# Urban Design Committee

# UDC 2022-27 CONCEPT Review

## Fire Training Facility 3000 East Belt Boulevard

# Proposal – Existing Trees

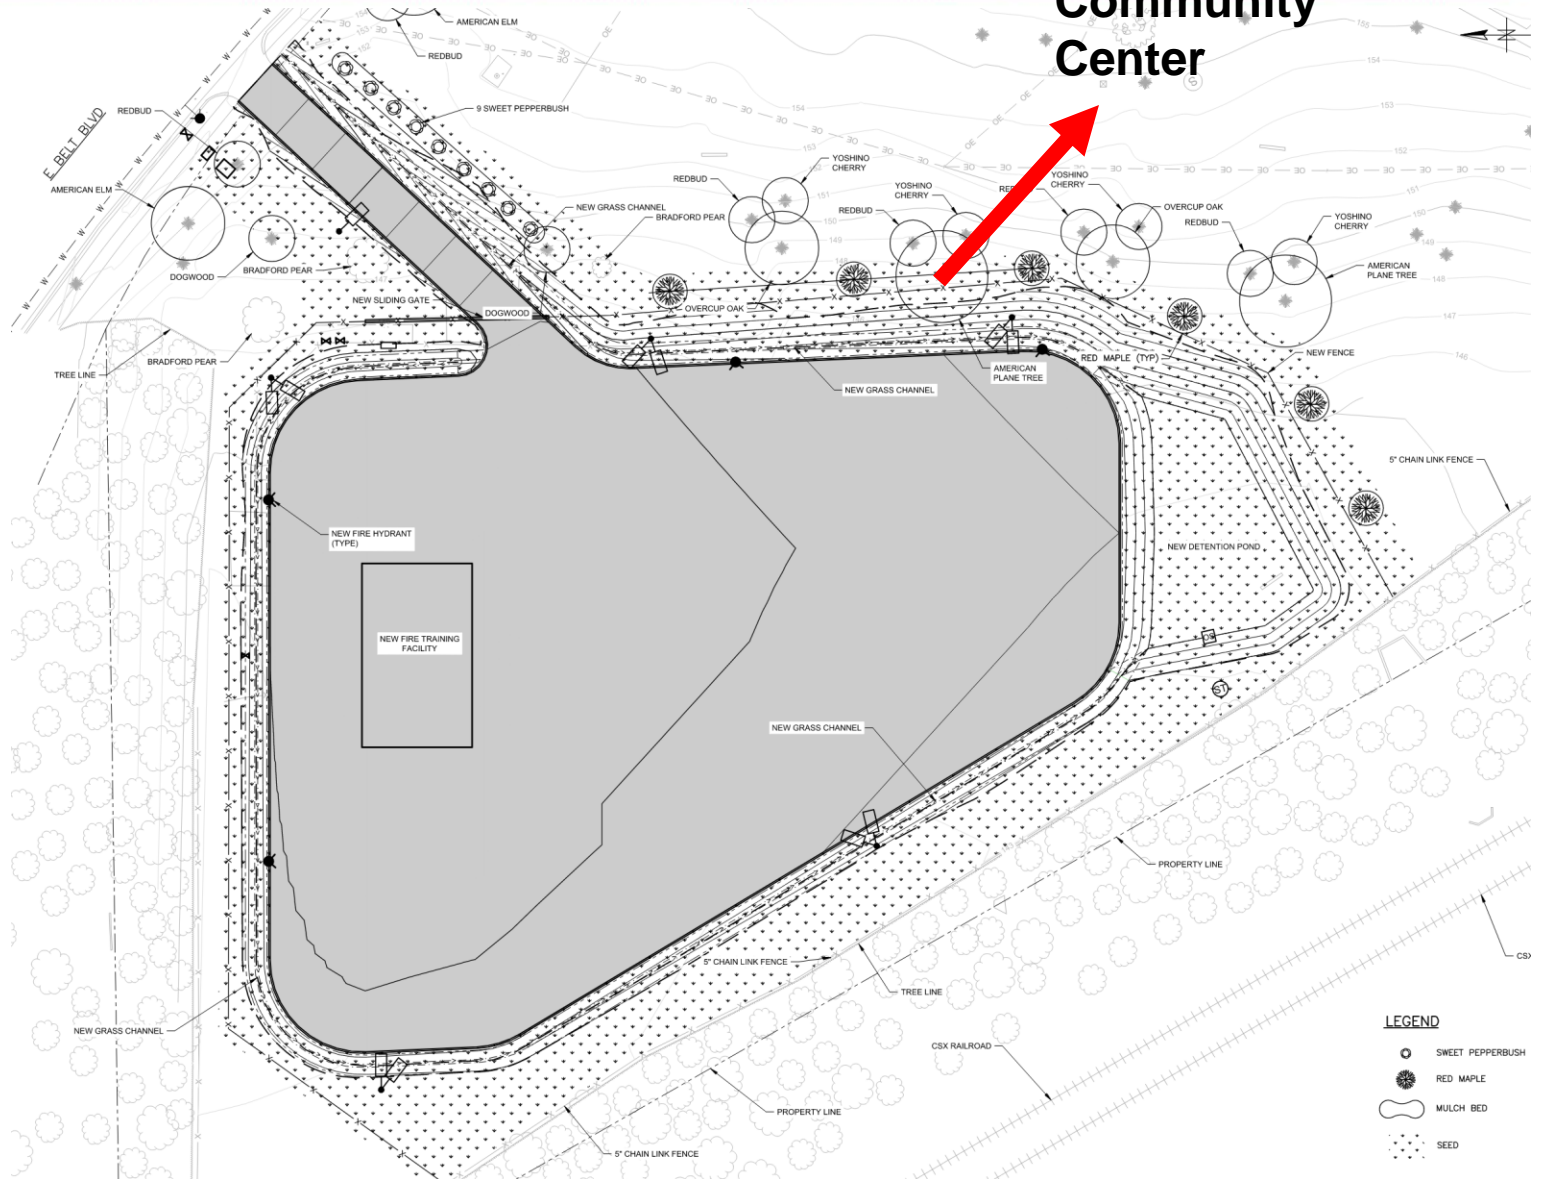
Staff recommends removal of Established Bradford Pears
